Access Compliance Report Public Rights-of-Way (Curb Ramps)

Main Street: **BRIMHALL_DR** Cross Street: **BELLWOOD_RD** Location: **NW**

ADA ID: **RPRK211207135904** Ramp Type: **Type 1 - Perpendicular Diagonal** Initial Pass/Fail: **Fail** Overall Compliance: **No** Severity Score: **2**

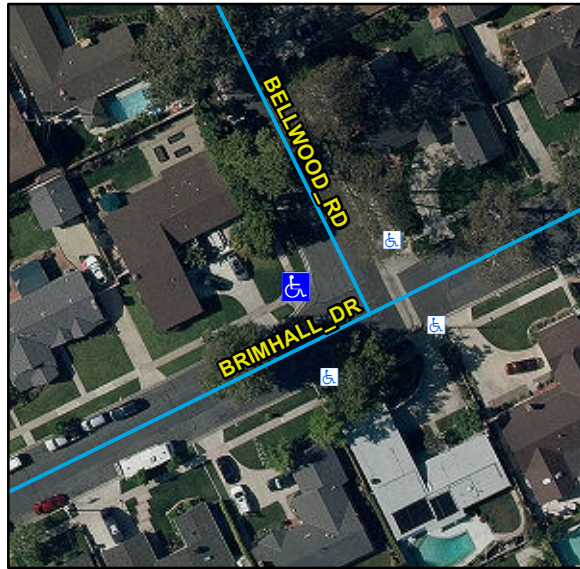
Compliance	Description	Data	Compliance	Description	Data
N/A	Ramp Length (in)	85	N/A	Flare Type LT	
Yes	Ramp Width (in)	48			N/A
Yes	Ramp Run Slope (%)	5.7	N/A	Flare Slope LT (%)	N/A
No	Ramp Cross Slope (%)	2.5	N/A	Flare Traversable LT	N/A
N/A	Landing Present	N/A	N/A	Flare Type RT	
N/A	Landing Length (in)	N/A			N/A
N/A	Landing Width (in)	N/A	N/A	Flare Slope RT (%)	N/A
N/A	Landing Run Slope (%)	N/A	N/A	Flare Traversable RT	N/A
N/A	Landing Cross Slope (%)	N/A	N/A	DWS Provided	N/A
N/A	Landing Movement Obstructed?	N/A	N/A	DWS Contrast	N/A
	Landing Movement Type	N/A	N/A	DWS Length (in)	N/A
N/A	Landing Shared	N/A	N/A	DWS Full Width	N/A
N/A	Clear Space	Yes	N/A	DWS Offset Left (in)	N/A
N/A	Clear Space To Crosswalk (in)	N/A	N/A	DWS Offset Right (in)	N/A
N/A	Marked Crosswalk 1	No	N/A	Marked Crosswalk 2	No
	Crossing 1 Direction	S		Crossing 2 Direction	E
	Marked Crosswalk 1 Width (in)	N/A		Marked Crosswalk 2 Width (in)	N/A

Possible Solutions:
Remove & Replace Curb Ramp With Two New Directional Ramps or Equivalent.

OC Std/PROW:
R204.3, R304.5.3, STD 1115
